Draft Voluntary Remediation Workplan

Former Timber Treatment Products Facility

Re: Timber Treat Products Voluntary Remediation Workplan Comments

Proposed Remediation Addendum

Figure 3. Location of the proposed barrier over CCA contamination at the Timber Treat Products Site

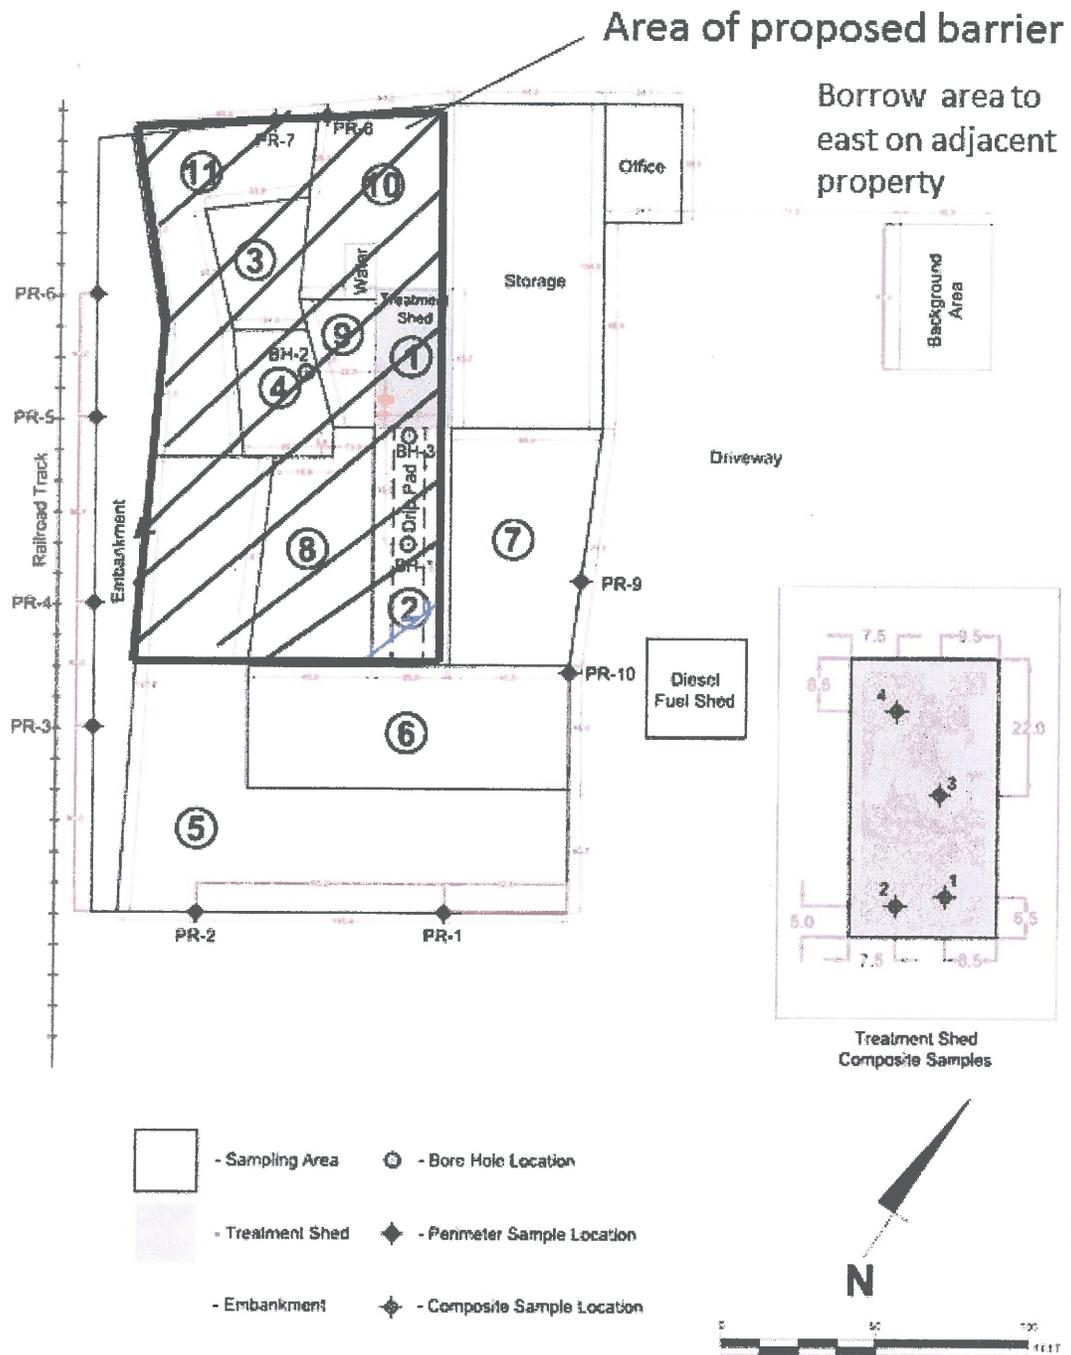
4. The cap must cover, at a minimum; the areas sampled which exceed the remediation goals. Areas of the property not capped should be sampled to demonstrate a cap is not needed.

Prior to preparing the site for placing the geotextile fabric, the lean-to shed will be removed. The site will be prepared to allow the geotextile fabric to be placed flat on the ground surface, and then borrow soil will be placed over the barrier to cover an 0.83 acre area. Borrow soil will be placed approximately 20 ft. beyond the border around the test site area. The borrow soil that is planned for the site cover is 96 feet northeast of the storage shed. This soil was tested, to determine the local background level of copper, chrome and arsenic by TerraGraphics, (QAPP 8.13). Result of the testing is located in Table one of the report. Therefore, the Trust finds it unnecessary and resists re-sampling the barrier soil which will be borrowed from the site investigation background test site. Borrow soil from the tested background area, will be used to cover the areas indicated in Sampling Area Locations. TerraGraphics Final, Site Investigation Report, Figure 2, p.4
